City of Albuquerque

RE: Engineer's Certification Plan for Dion's at Cottonwood Mall (B13/D18) Submitted for Certificate of Occupancy Approval, Engineer's Certification Stamp Dated 3/23/00.

C1

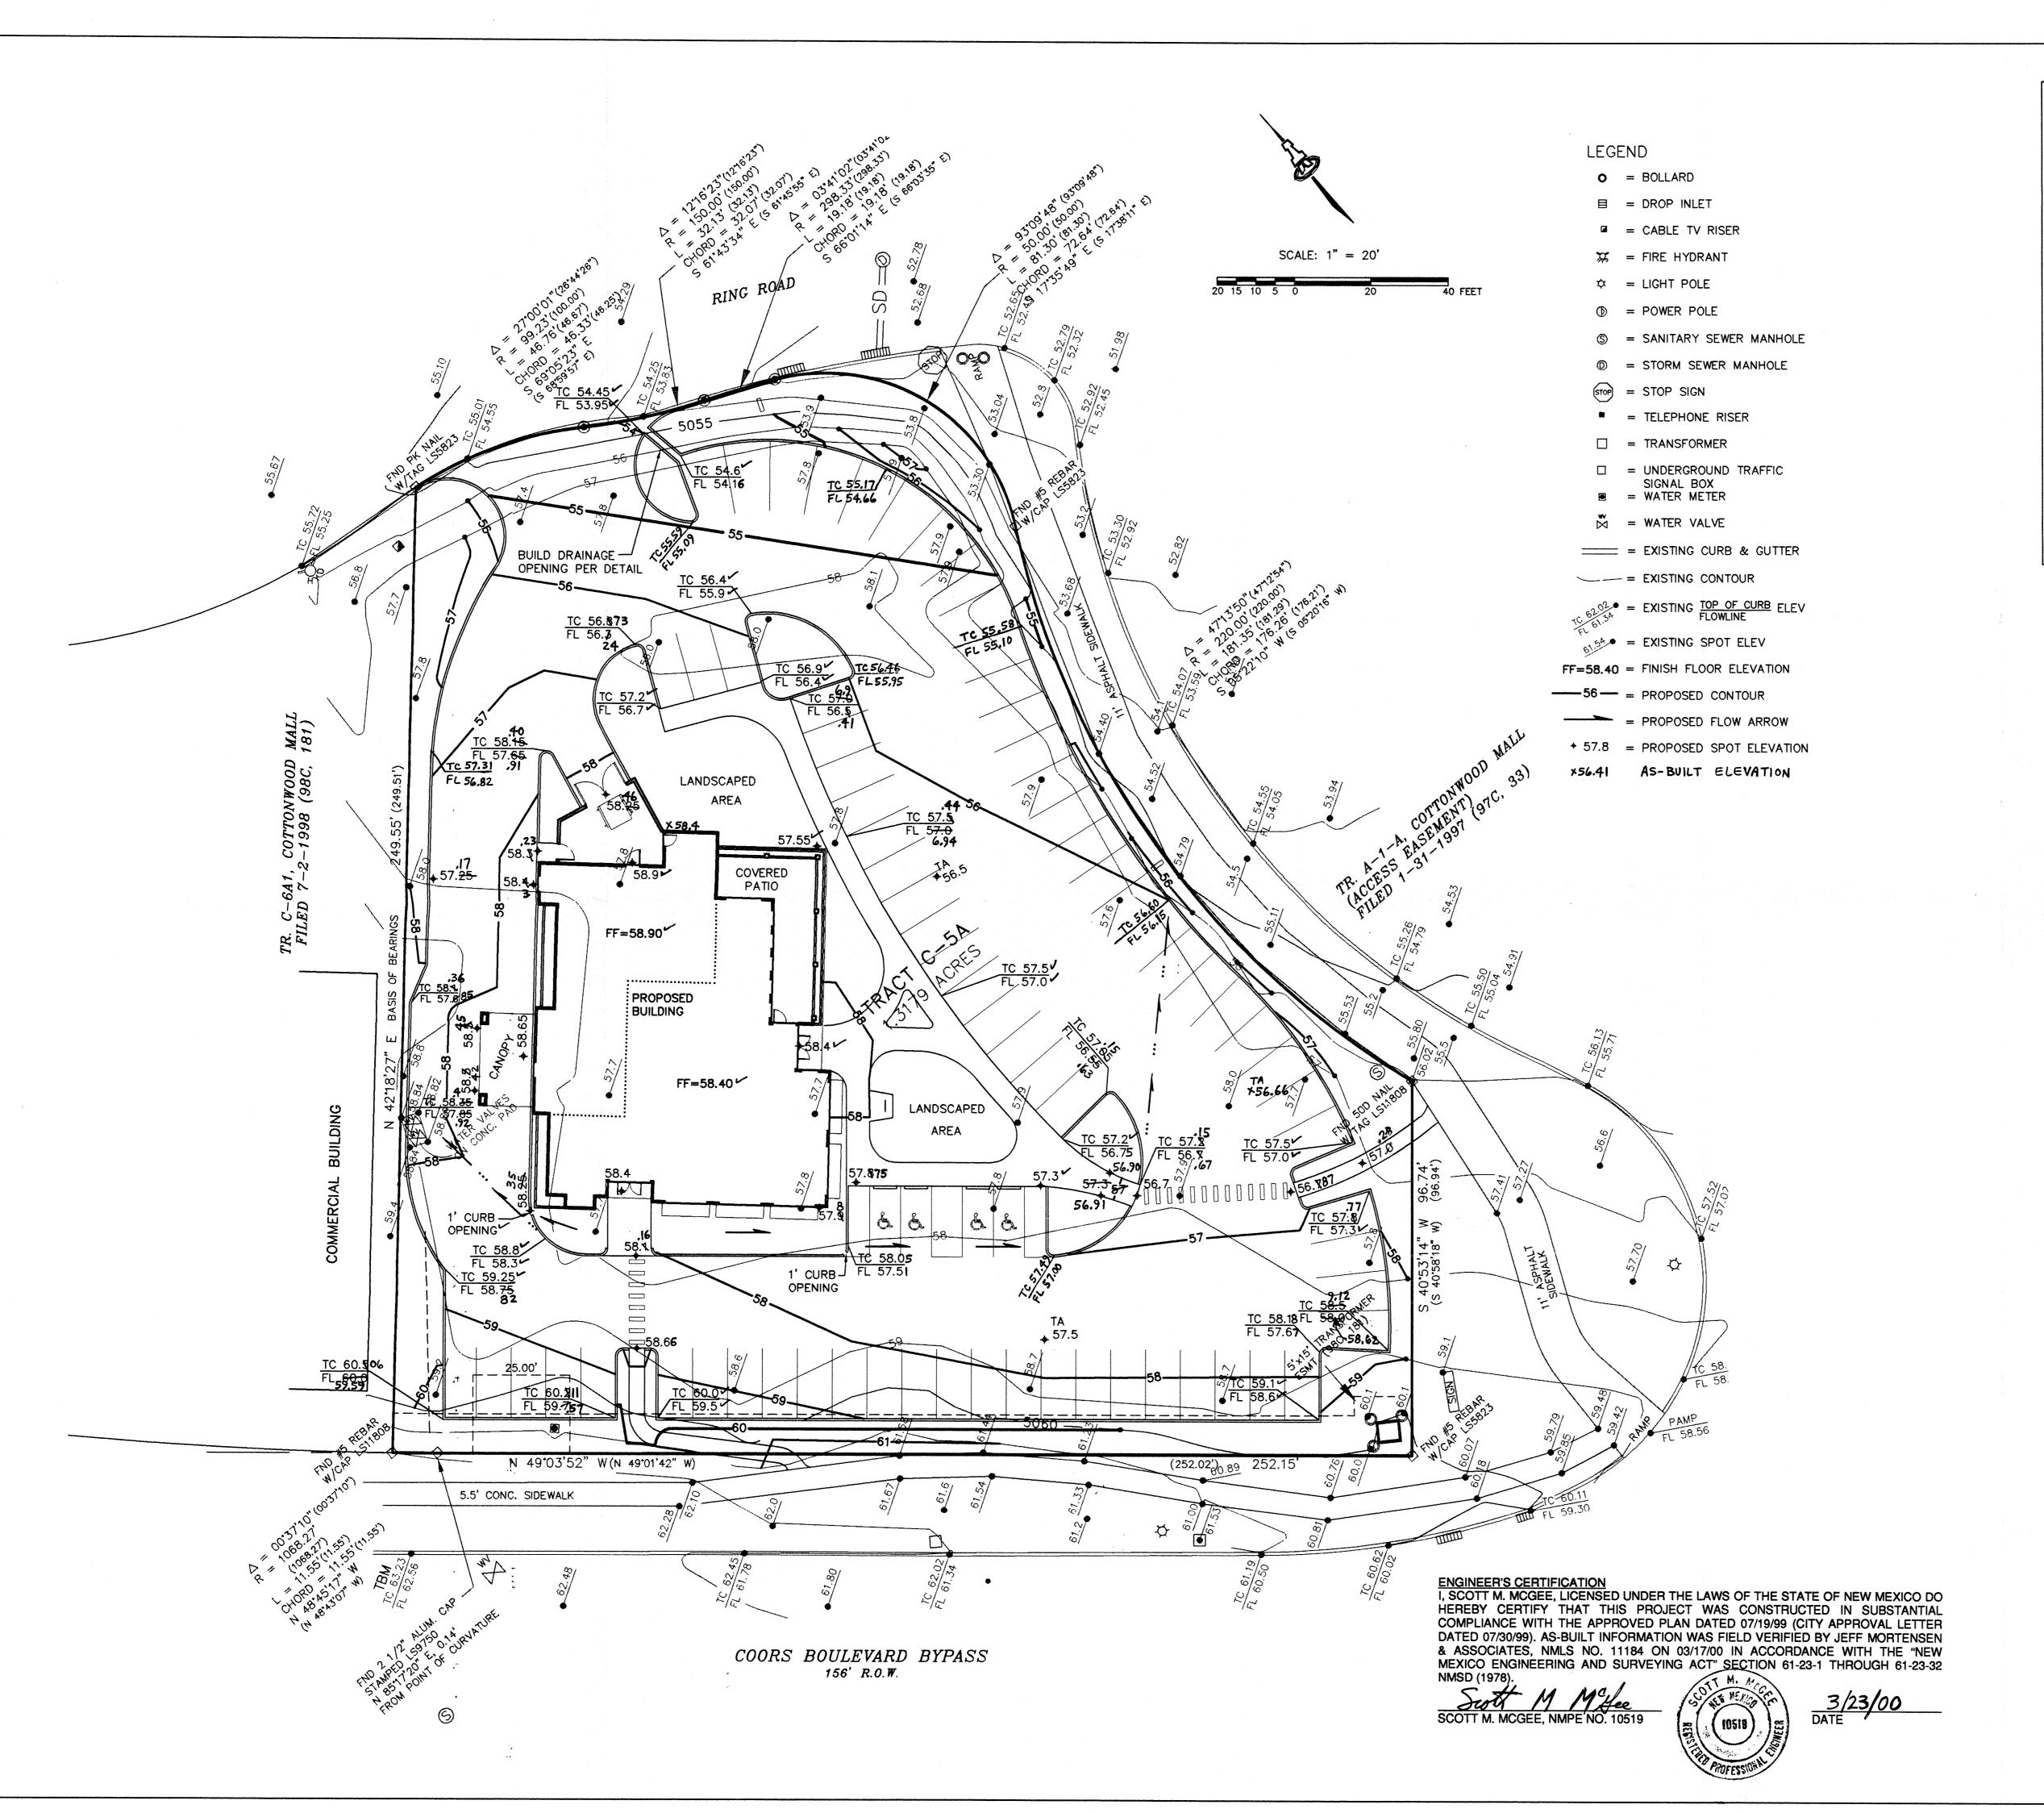
Based on the information provided, the above referenced Engineer's Certification plan is adequate for the release of the permanent Certificate of Occupancy for the Dion's located at 10,010 Coors Boulevard Bypass NW.
